UNITED STATES PATENT AND TRADEMARK OFFICE

APPLICATION NO.	FILING DATE	FIRST NAMED INVENTOR	ATTORNEY DOCKET NO.	CONFIRMATION NO.
10/604,953	08/28/2003	Shaun Wright		1952
37991 7590 04/10/2007 THE LAW OFFICE OF ROBERT R. WARD, JR., ESQ. 8170 SW 93RD AVE MIAMI, FL 33173			EXAMINER CHAMBERS, TRAVIS SLOAN	
			ART UNIT 2833	PAPER NUMBER
SHORTENED STATUTORY PERIOD OF RESPONSE	MAIL DATE	DELIVERY MODE		
3 MONTHS	04/10/2007	PAPER

DETAILED ACTION

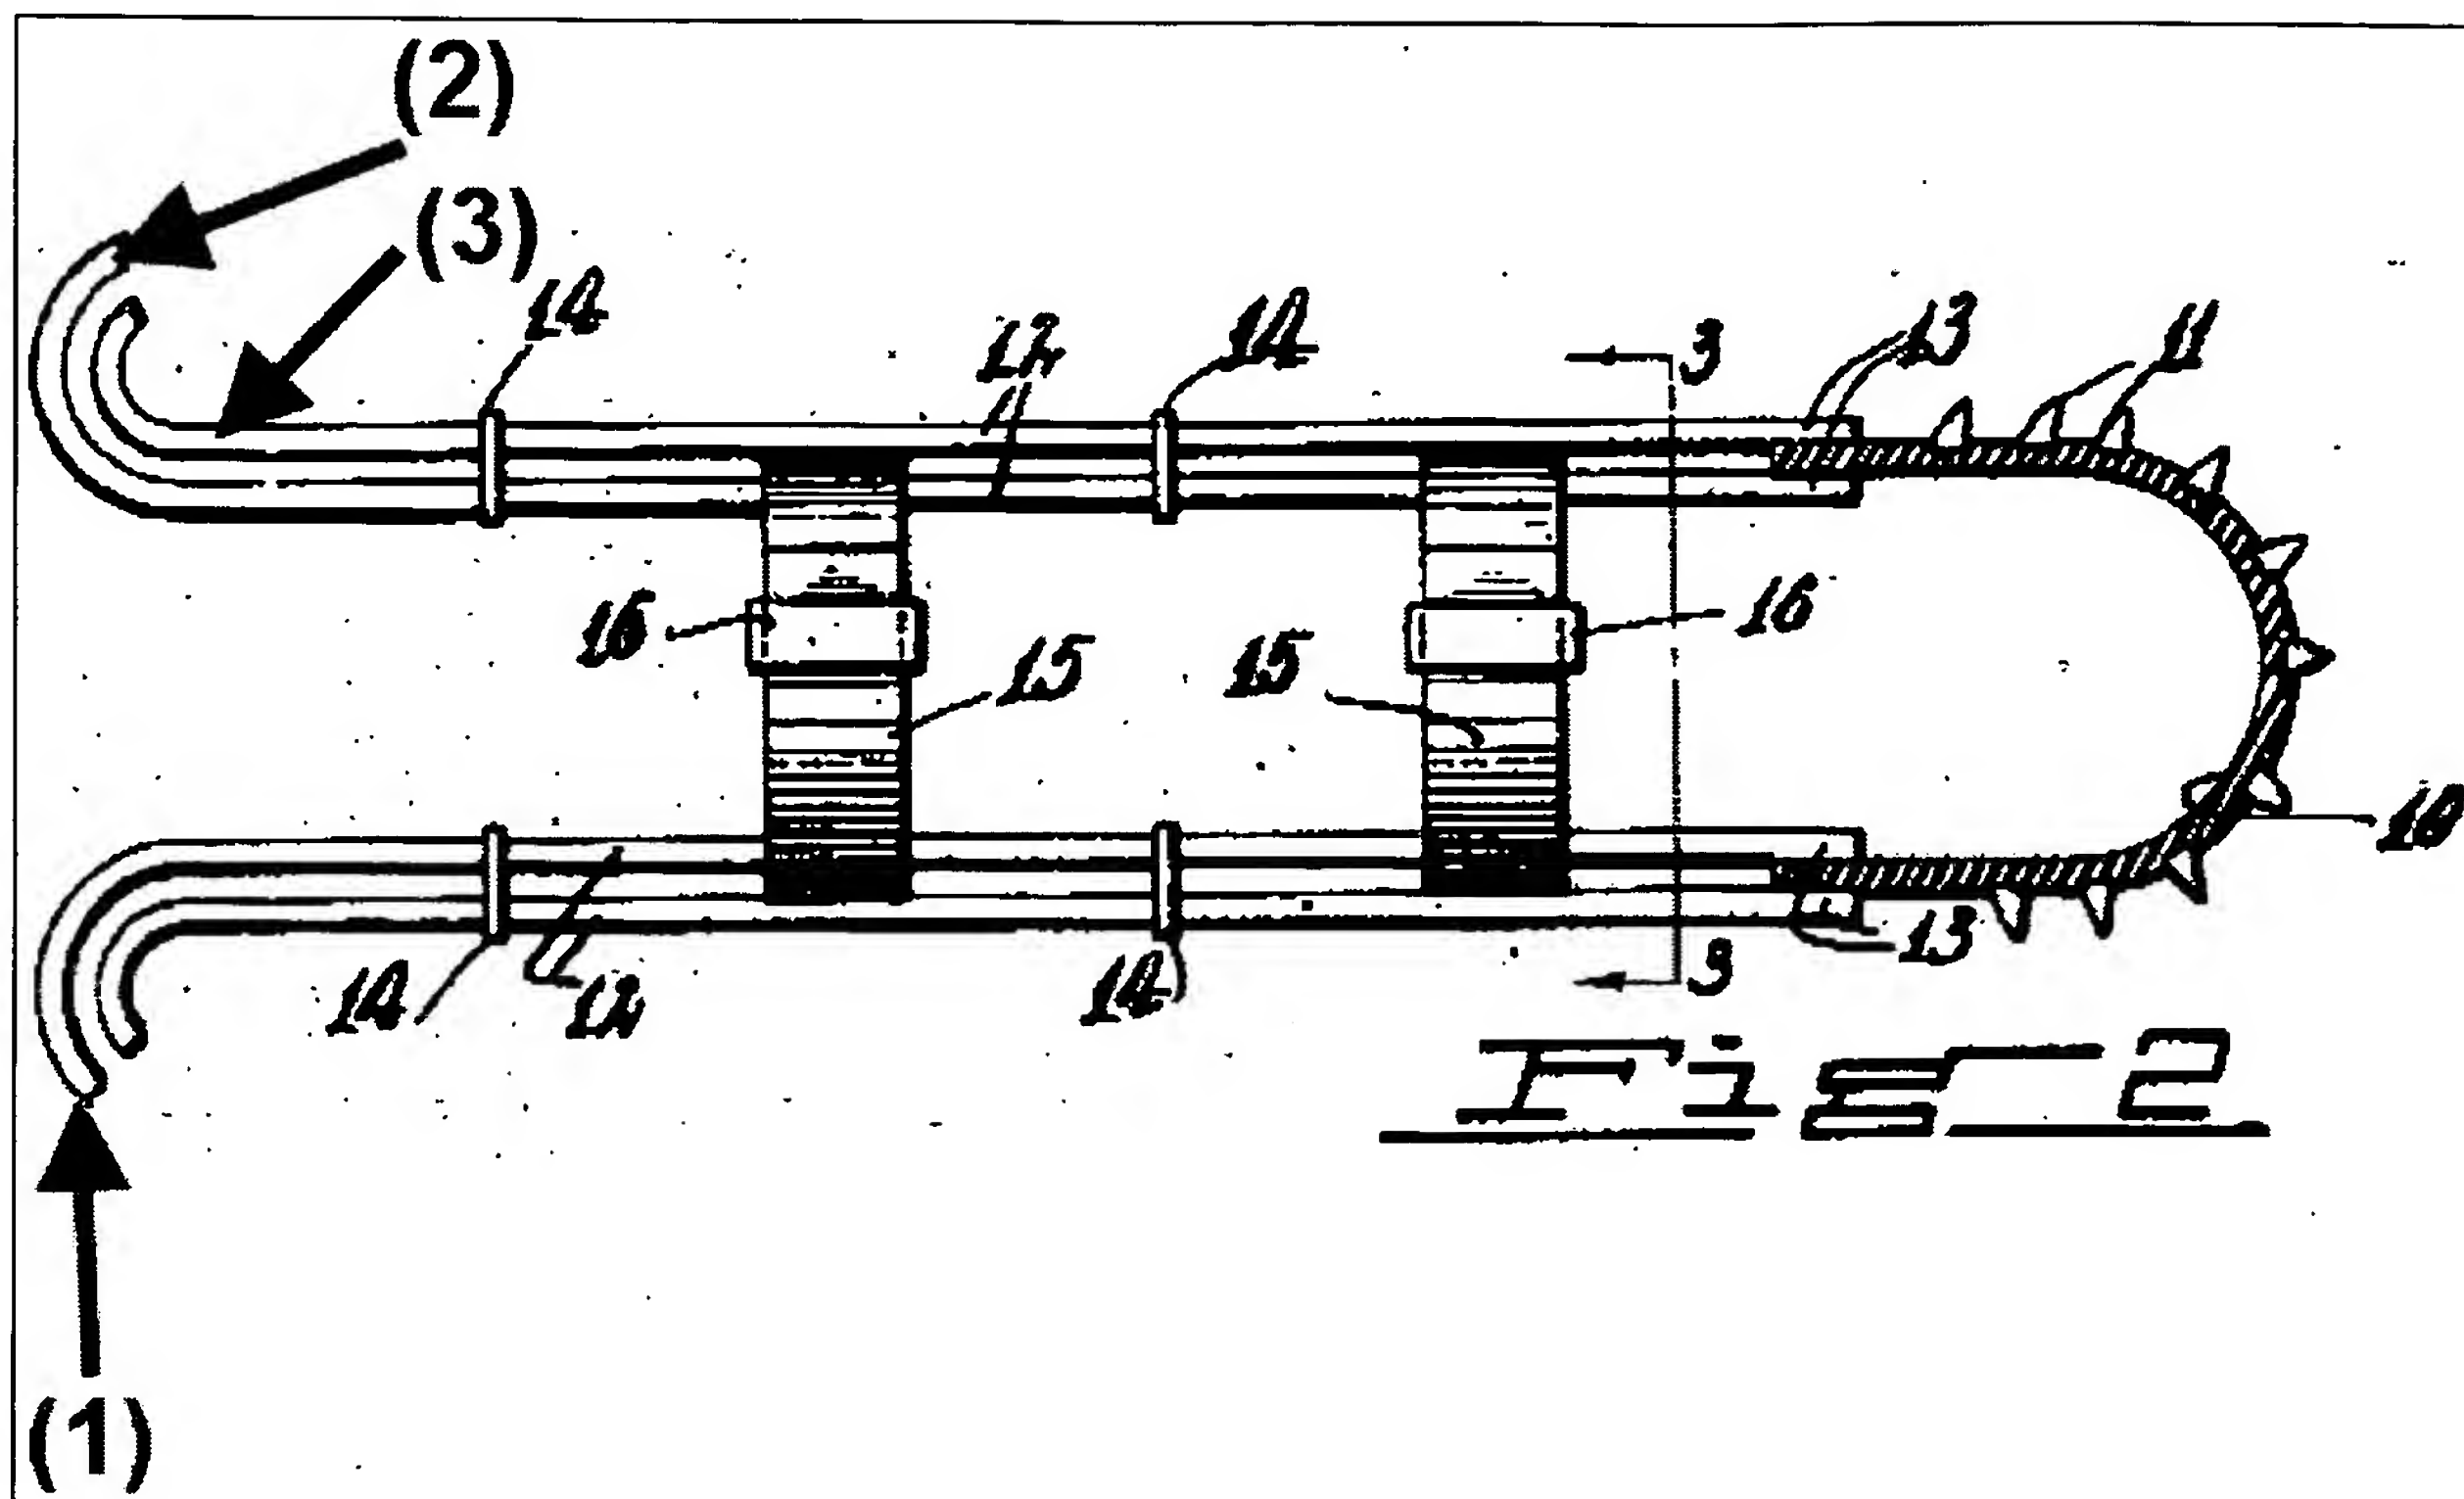
In reference to claim 1, Gonzalez teaches a globular shaped body (10 ; figure 1) made entirely from material designed to illicit specific sounds when placed in contact with one or more strings of a stringed musical instrument having a tapered inner surface (near lead line 10 ; figure 2) means to receive a musician's finger, an inner end having a hole (near lead line 13 ; figure 2) adapted to receive a musician's finger, a closed outer end (top portion 10 ; figure 2), and an outer surface for contacting strings of a stringed musical instrument encompassing said closed outer end (top portion 10), a finger ring (15 ; figure 2) and a means connecting the globular body (10) to the finger ring (15) allowing a musician's finger to bend normally.

In reference to claim 3, Gonzalez teaches a tapered cylindrical shaped body (10 ; figure 1) made entirely from material designed to illicit specific sounds when placed in contact with one or more instrument having a tapered inner surface (near lead line 10 ; figure 2) means to receive a musician's finger, an inner end having a hole (near lead line 13 ; figure 2) adapted to receive a musician's finger, a closed outer (top portion 10 ; figure 2) end extending beyond the musician's finger, and an outer surface for contacting strings of a stringed musical instrument encompassing the closed outer end (top portion 10), a finger ring (15 ; figure 1) and ;a means connecting the cylindrical shaped body (10) to the finger ring (15) allowing a musician's finger to bend normally.

In reference to claims 5 and 7, Gonzalez teaches where the means to connect the finger ring (15) and the globular body (10) are at least two semi-rigid strips (1,2 ;image below .

In reference to claims 9 and 11, Gonzalez teaches where the means to connect the finger ring (15) and the globular body (10) are three semi-rigid strips (1,2,3 ; image below).

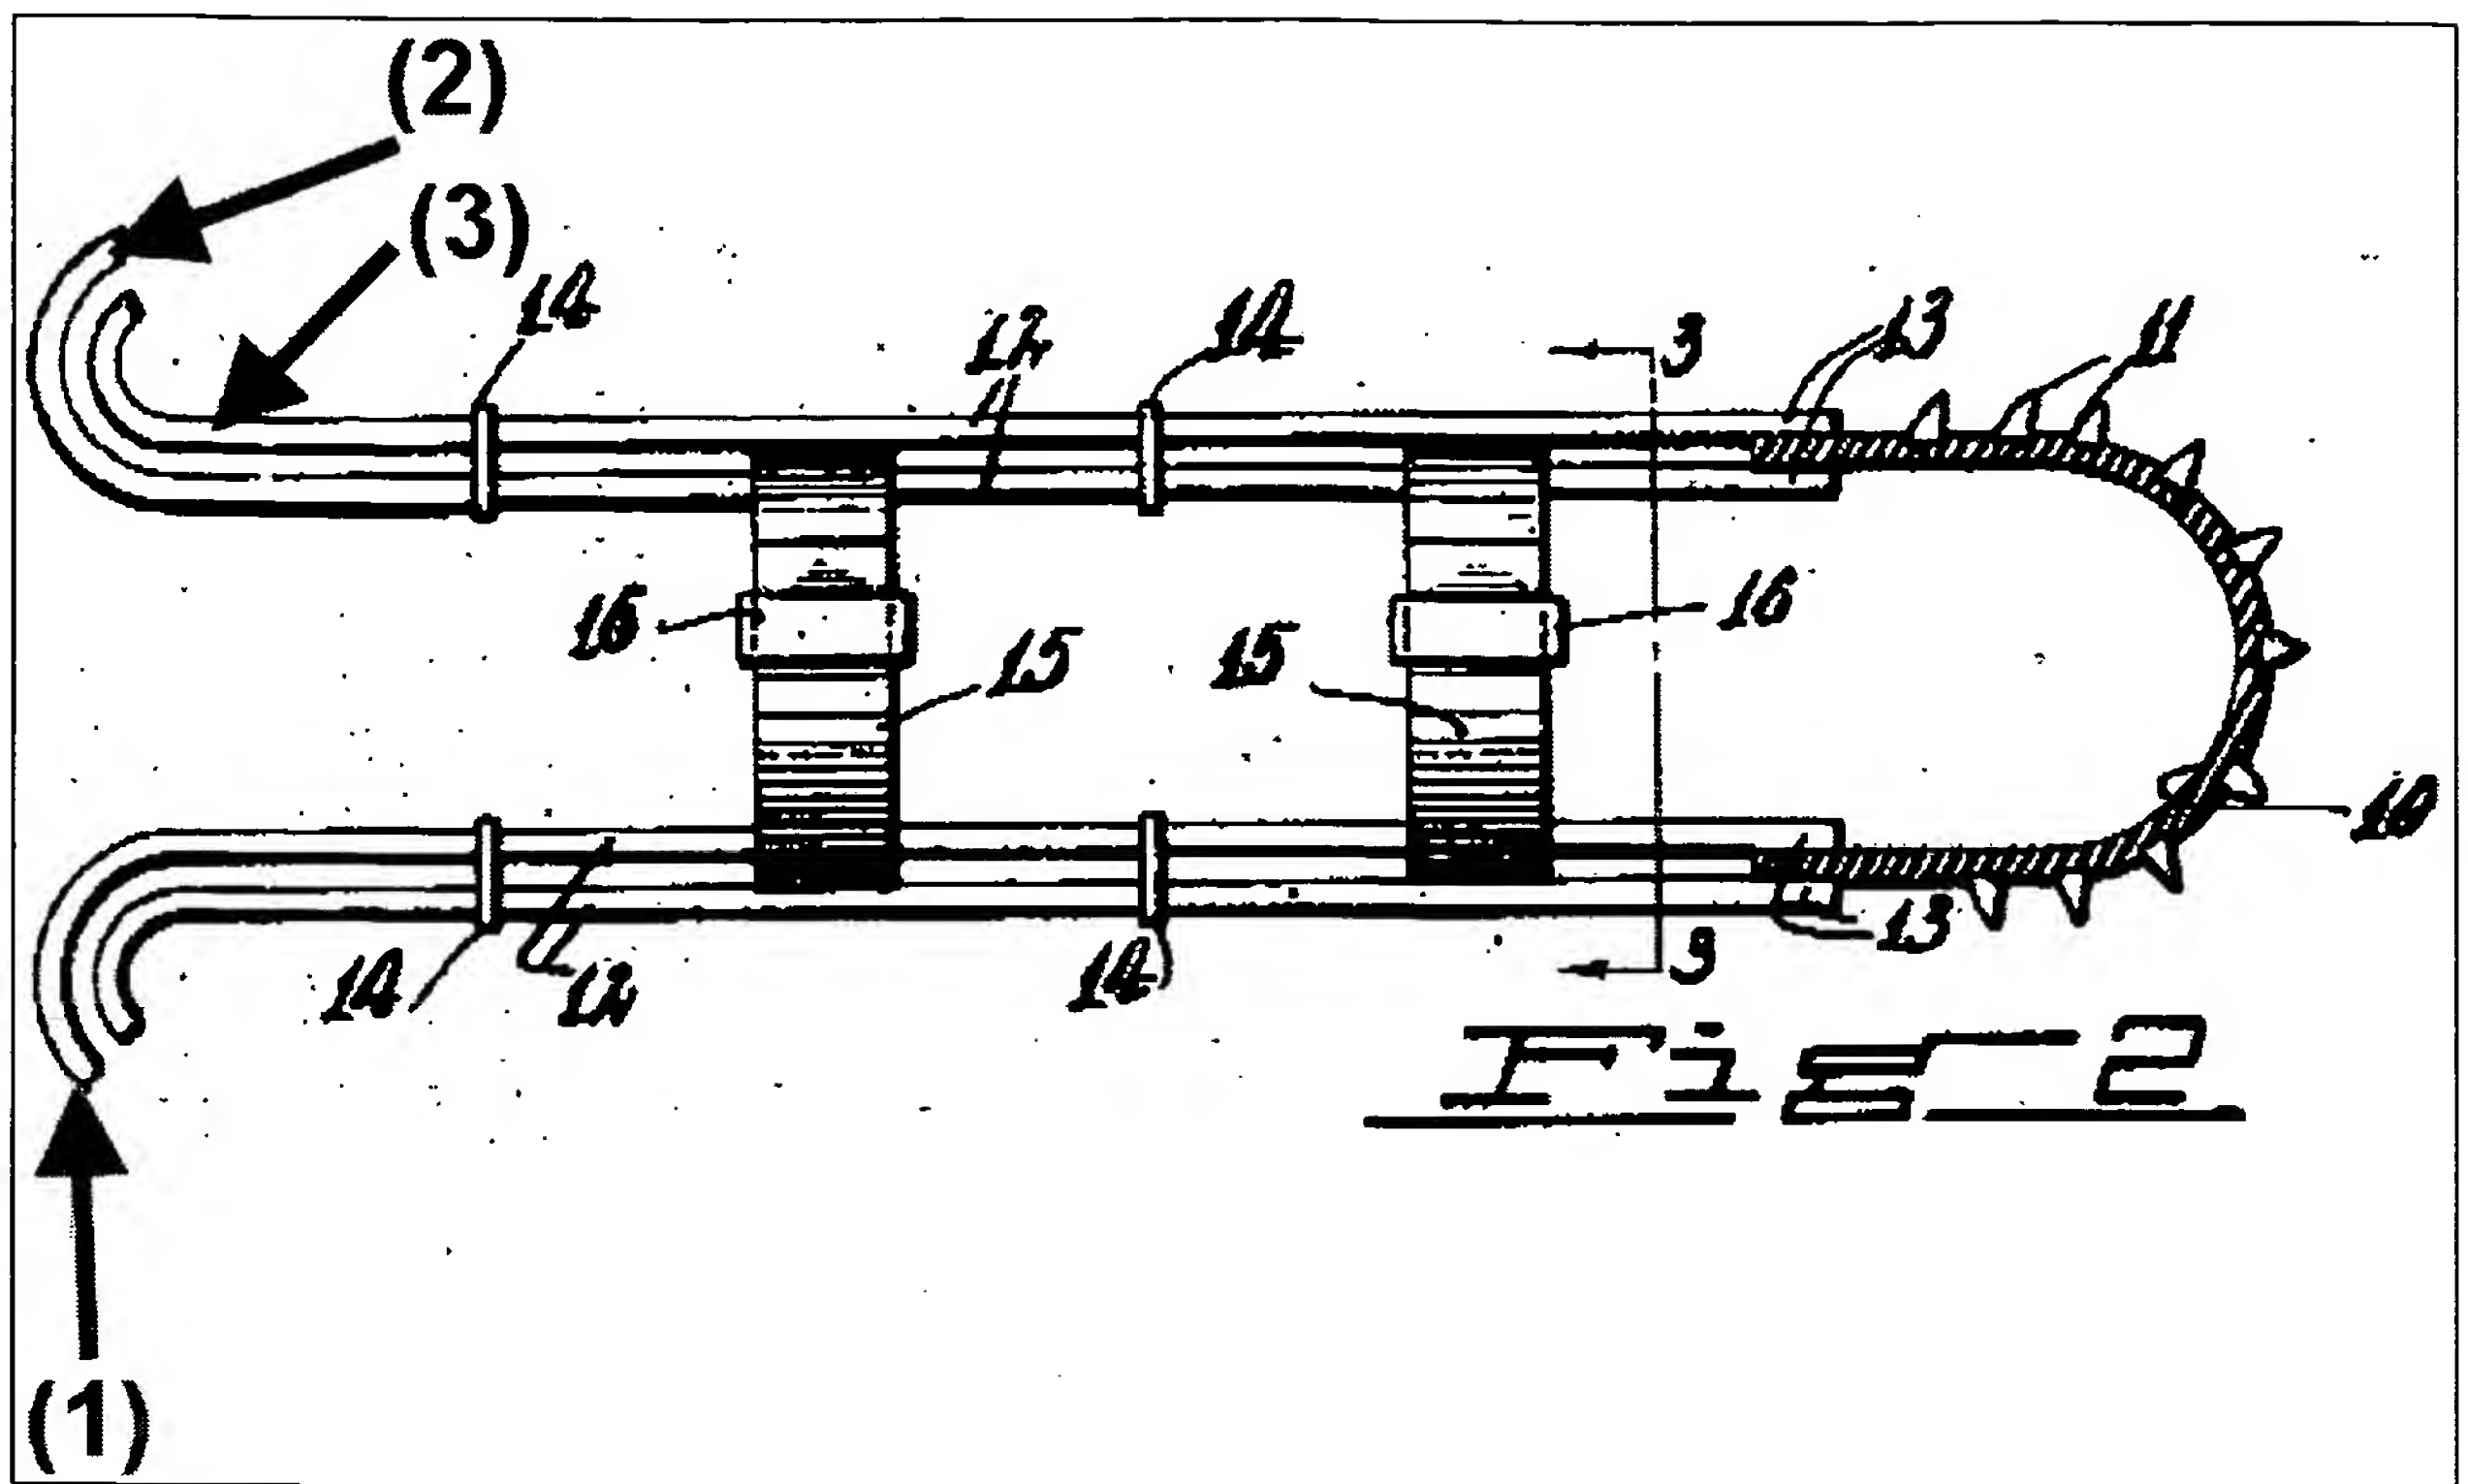
It is known in the art to change the shape of the outer surface so it can have a groove. Jones is an example that teaches of a groove (between 5 ; figure 2) present transversely across the outer surface (3 ; figure 1).

It would have been obvious at the time of the claimed invention to change the shape of the outer surface, since such a modification would have involved a mere change in the shape of a component. A change in shape is generally recognized as being within the level of ordinary skill in the art. In re Rose, 105 USPQ 237 and (CCPA 1955), In re Dailey, 149 USPQ 47 (CCPA 1976).

In reference to claims 6 and 8, Gonzalez teaches where the means to connect the finger ring (15) and the globular body (10) are at least two semi-rigid strips (1,2 ; image below) .

In reference to claims 10 and 12, Gonzalez teaches where the means to connect the finger ring (15) and the globular body (10) are three semi-rigid strips (1,2,3; image below).
